NCSU BROOKS HALL PHASE I RENOVATION

SC0#22-25338-02A NCSU#20222002

11 05 24 - ADDENDUM 01

101 FLOOR 1 - MECHANICAL NEW DUCTWORK PLAN
SCALE: 3/16" = 1'-0"

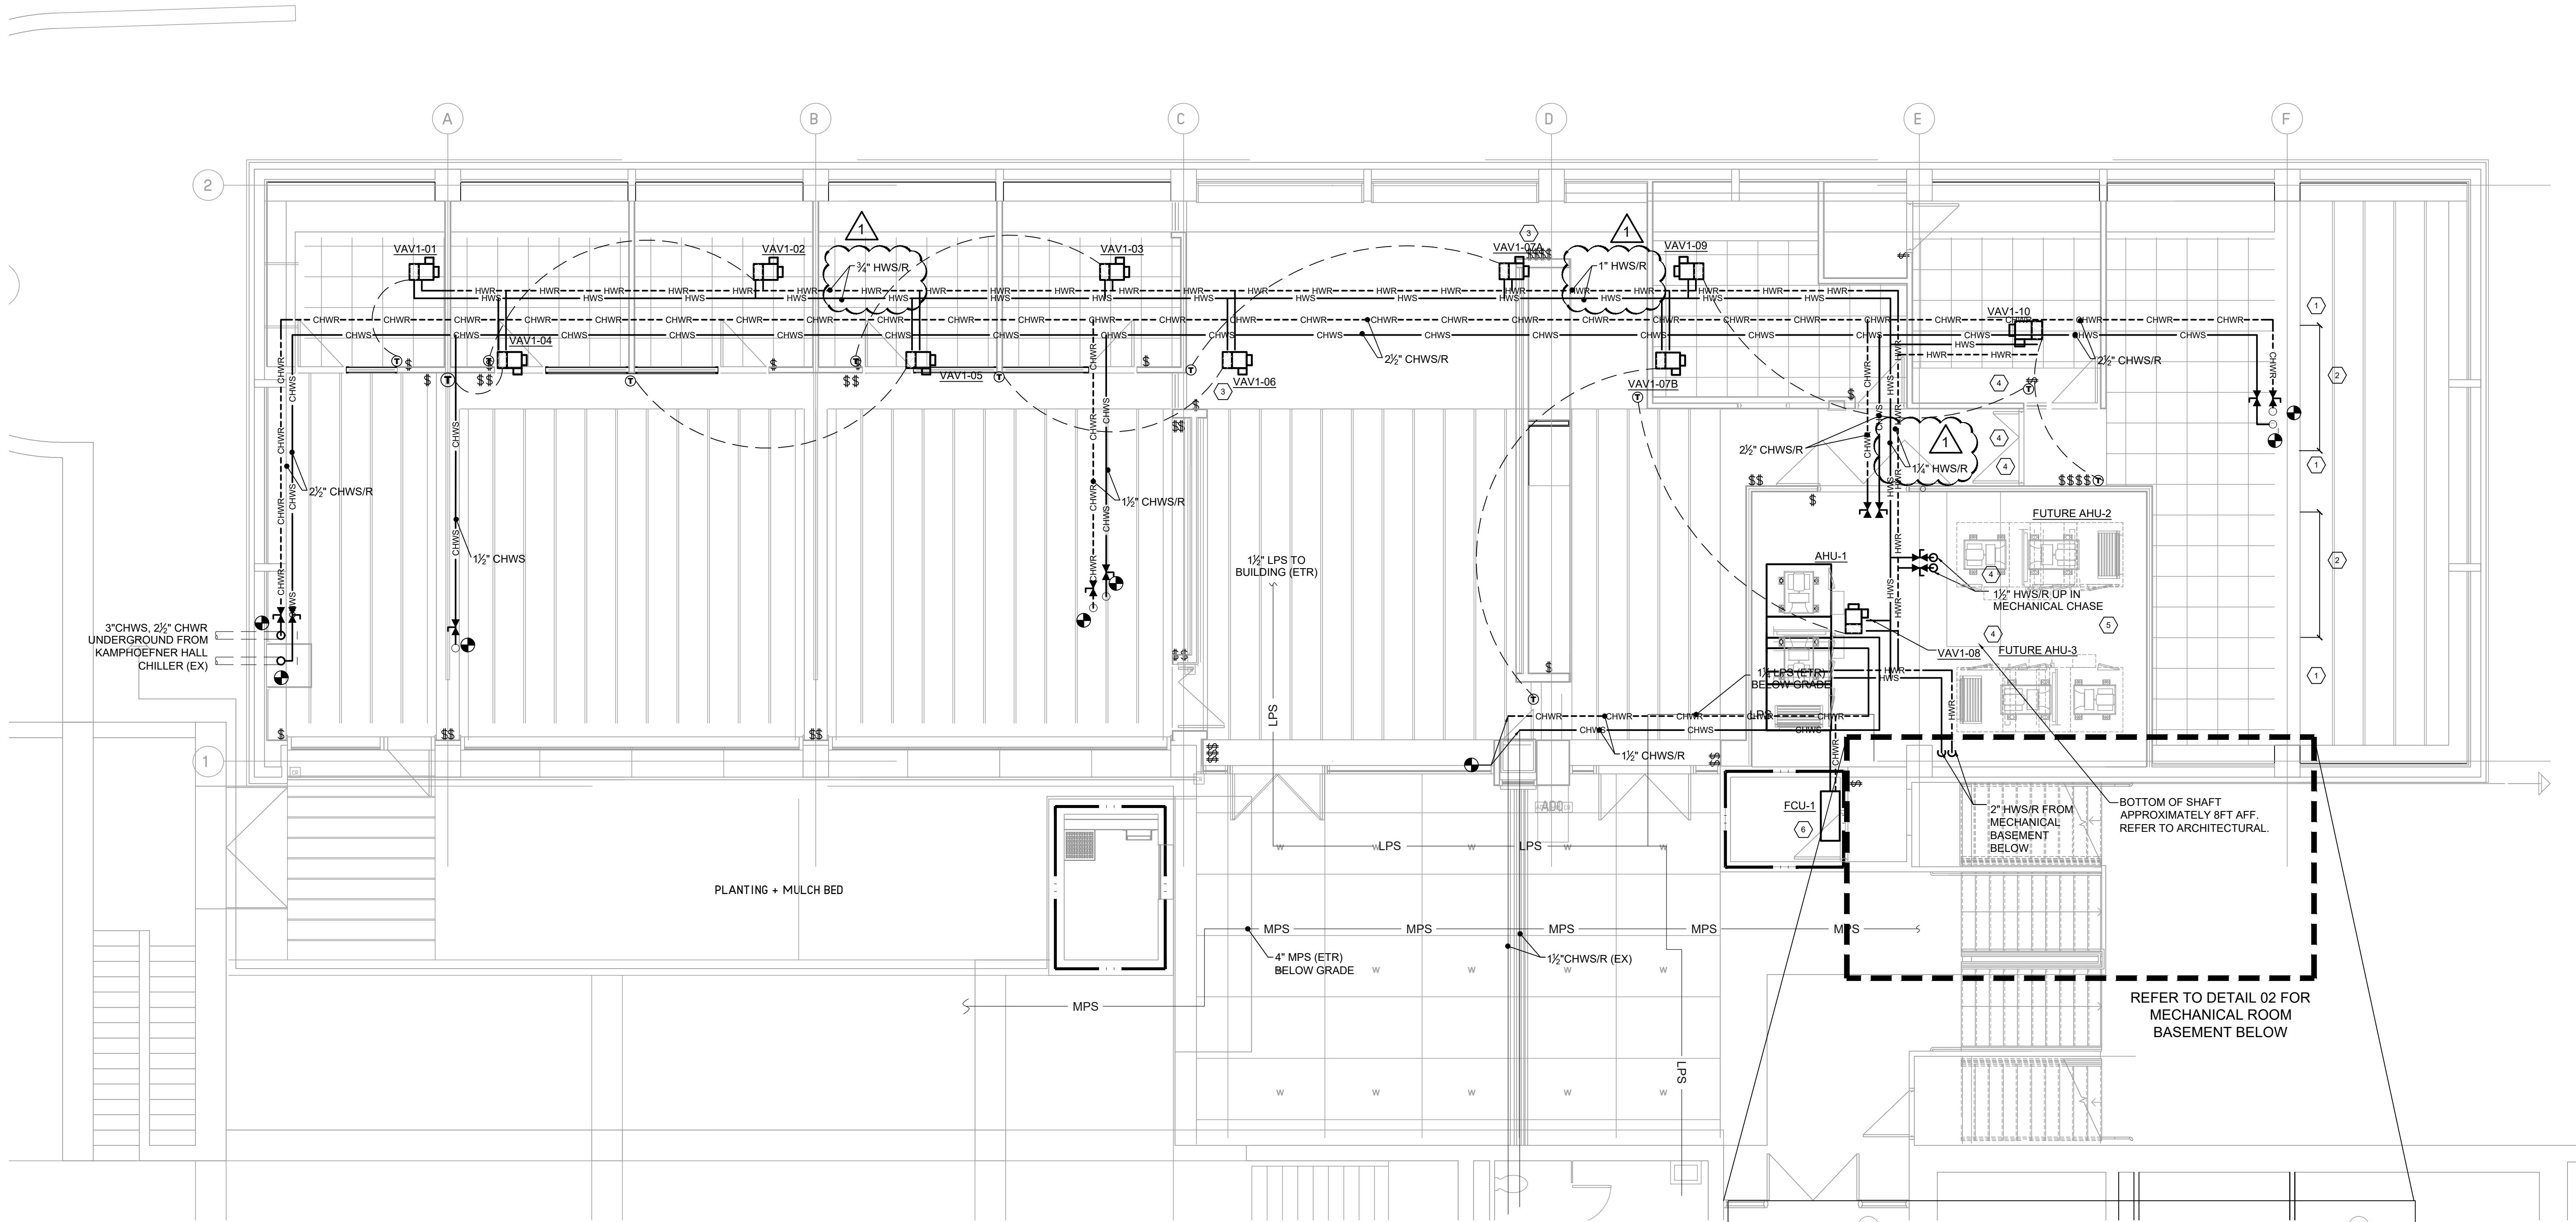
- M200 and M201 have been replaced as several duct sizes were missing.
- A0.2, A0.3, AB-1 have been issued in a 'flat' version for troubles with the file. No changes have been made to these sheets.

- Q: HVAC duct and pipe sizes are missing on M2.00 and M2.01.
A: See attached drawings for missing pipe and duct sizes. Piping sizes are listed on sheet M400. Runout sizes to VAV boxes shall be equivalent to the box inlet sizes.
